Re: 5 Villiers Road, Padstow Heights – Traffic Response to RFI

I have considered the relevant traffic and parking matters (17 & 18) contained in Council's RFI (DA-26/2025) of 18 March 2025.

Swept Path Assessment & Vertical Clearance Test

TITLE
SWEPT PATH ASSESSMENT
CLEARANCE TEST

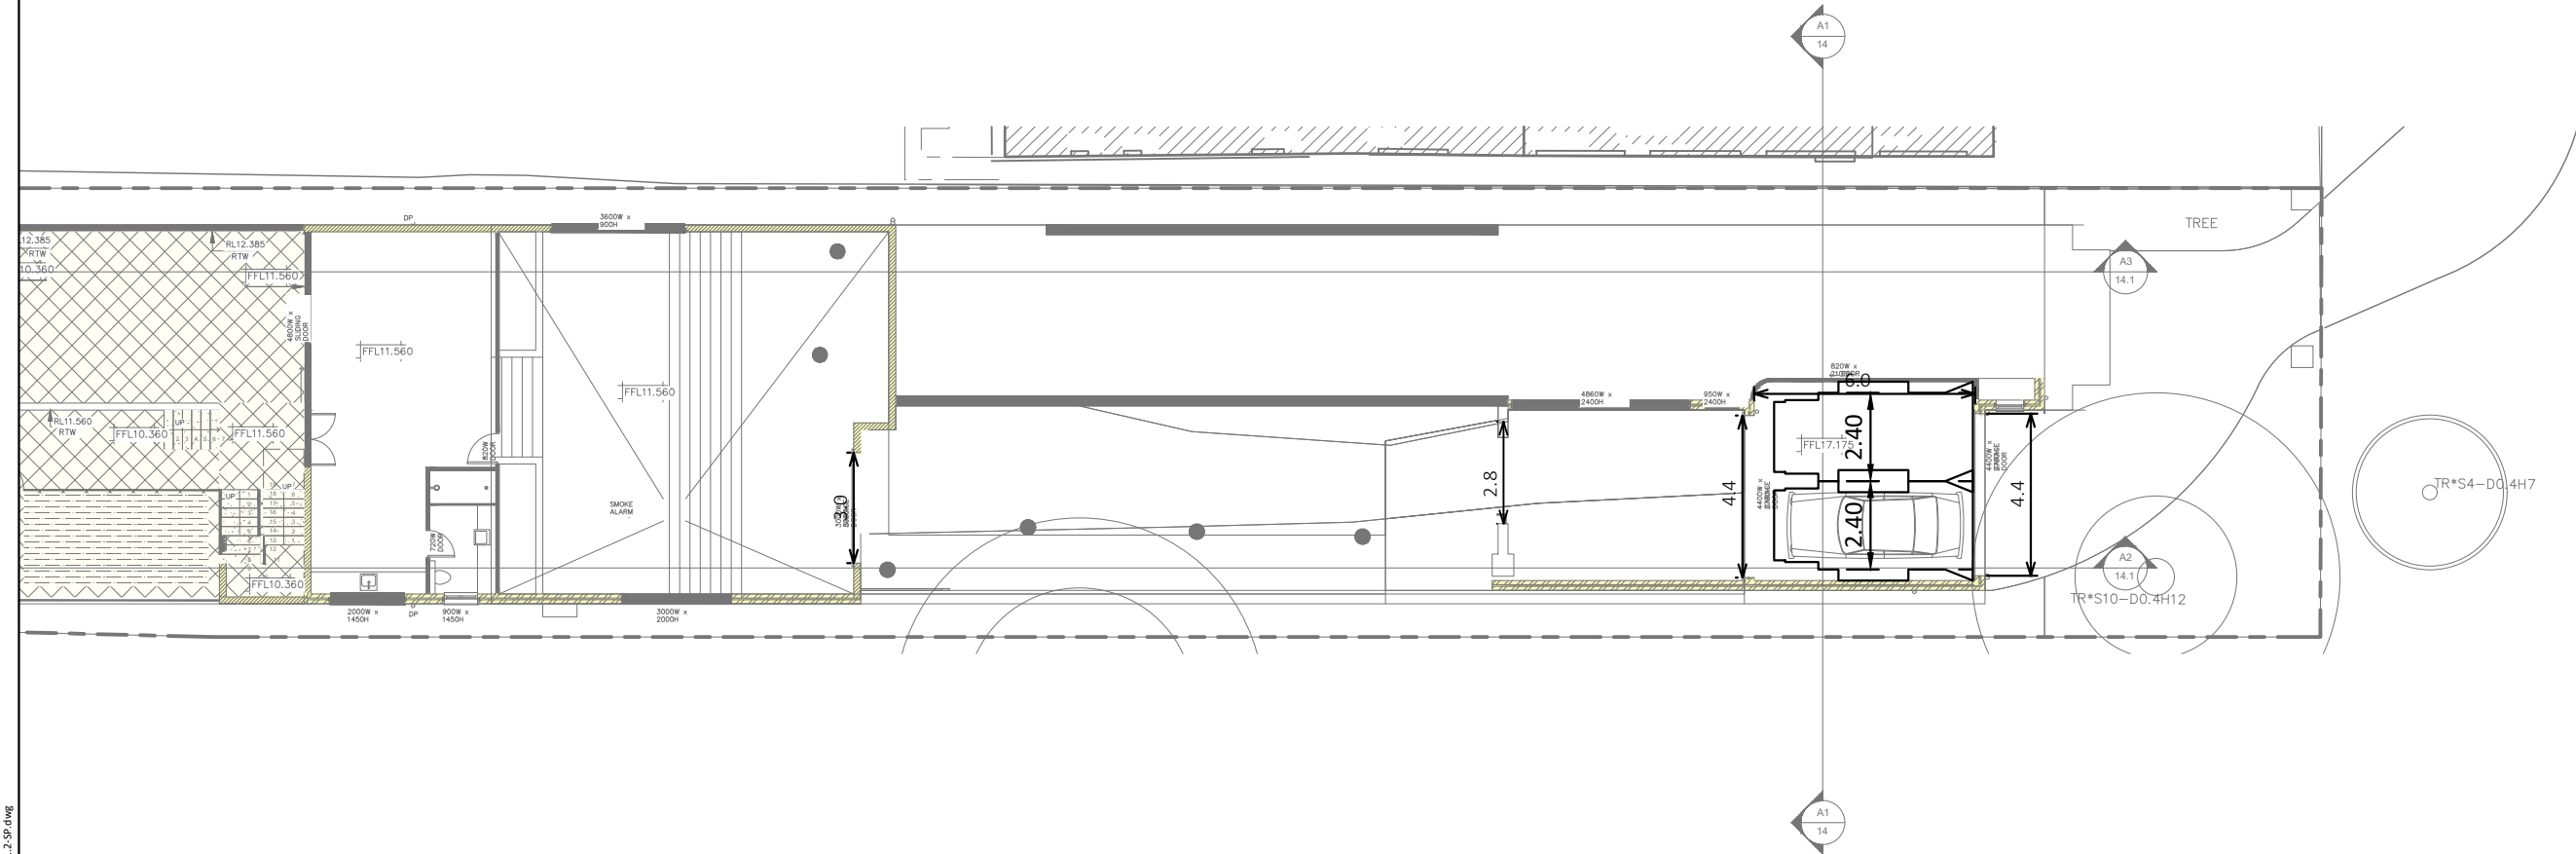
a. A vertical clearance check shall be provided to justify no scraping to new proposed driveway profile in accordance with AS2890.1.

A vertical clearance test demonstrating a standard design vehicle will not bottom/scrape when negotiating the ramp is provided in **Attachment 2**.

TITLE
SWEPT PATH ASSESSMENT
GARAGE ENTRY AND EXIT

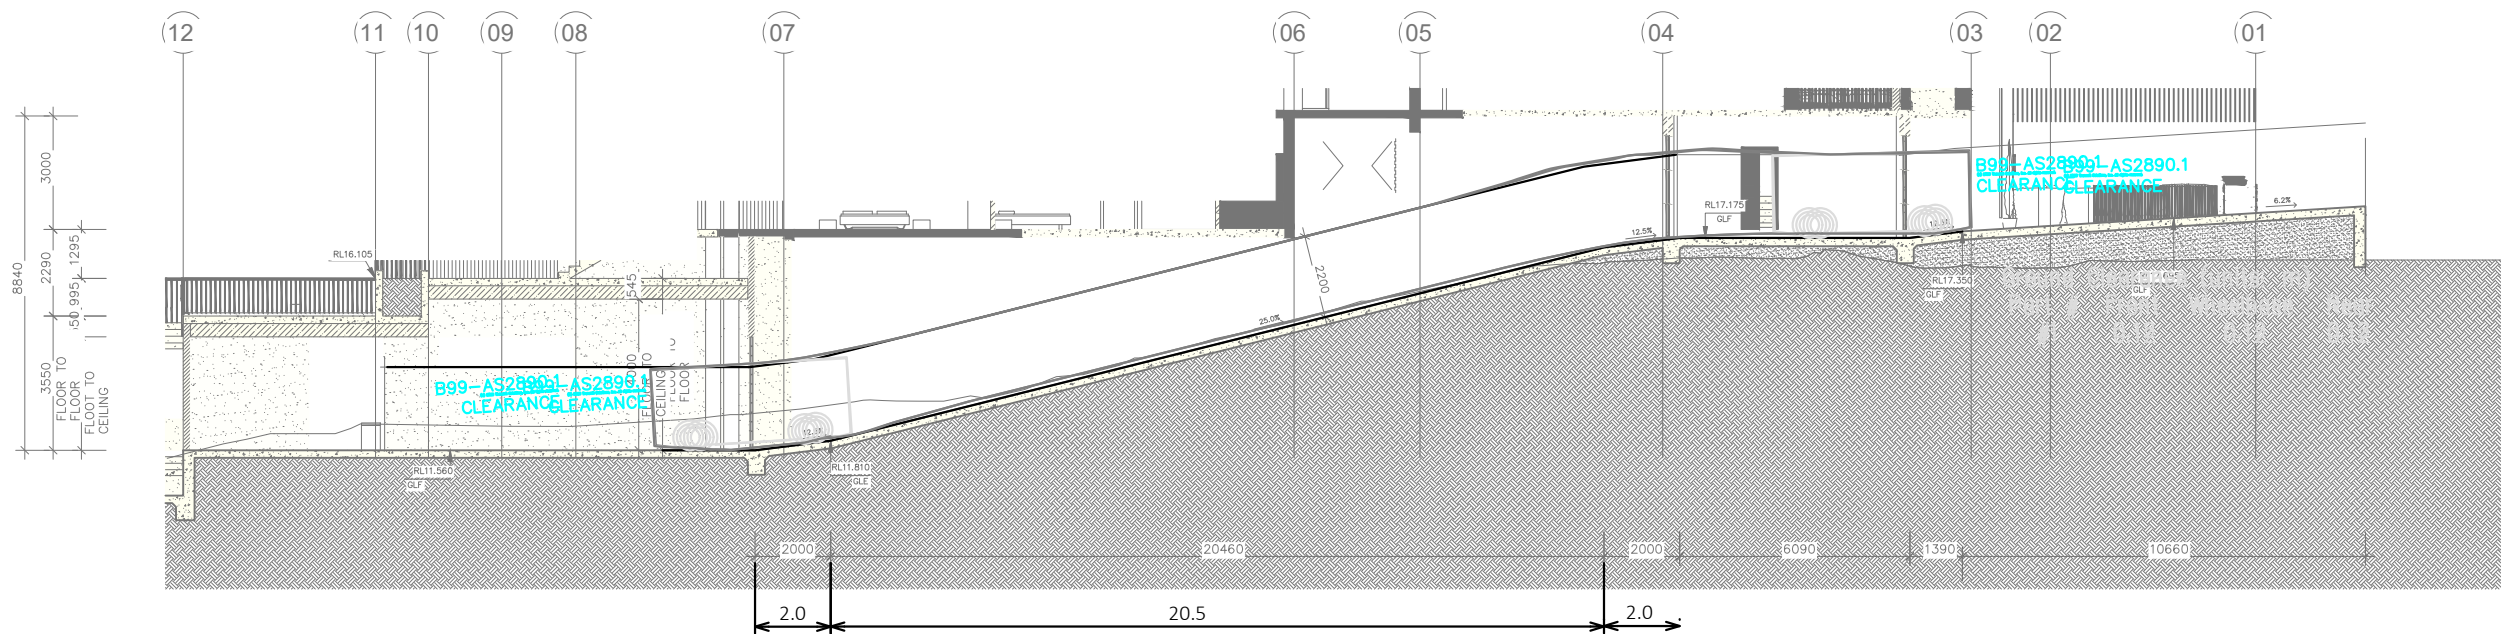
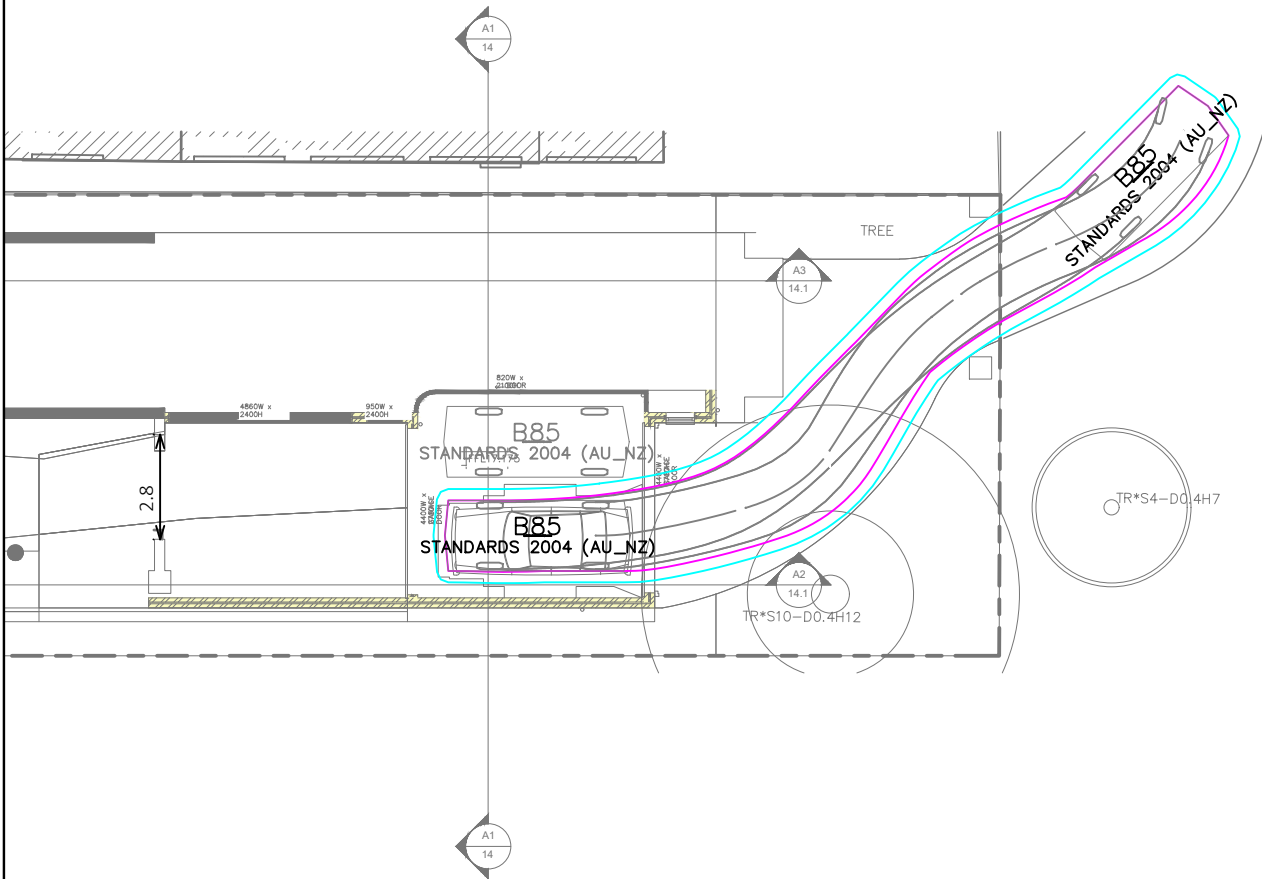
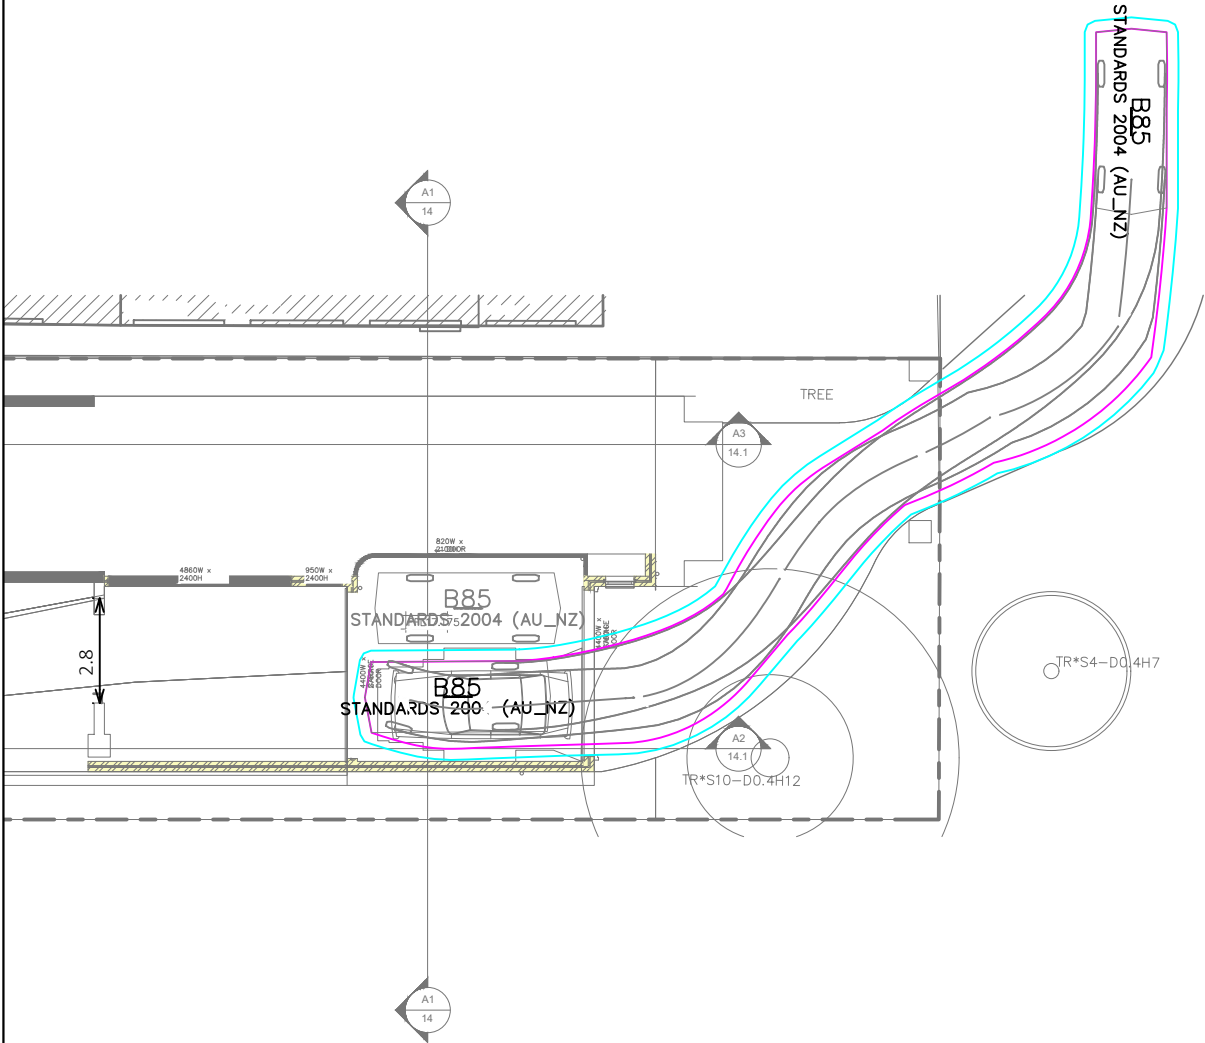
17. Proposed VFC (Vehicular Footway Crossing)

a. The existing VFC & roadway leading to the site does not line up with proposed internal driveway. You shall provide a swept path analysis demonstrating vehicles are capable of manoeuvring from the street to the basement and exit in a forward direction.

The swept path assessment has been undertaken in response to Council's request. The assessment has demonstrated that vehicles can enter and exit the site with no undue difficulty, confirming satisfactory manoeuvring provision (**Attachment 2**).
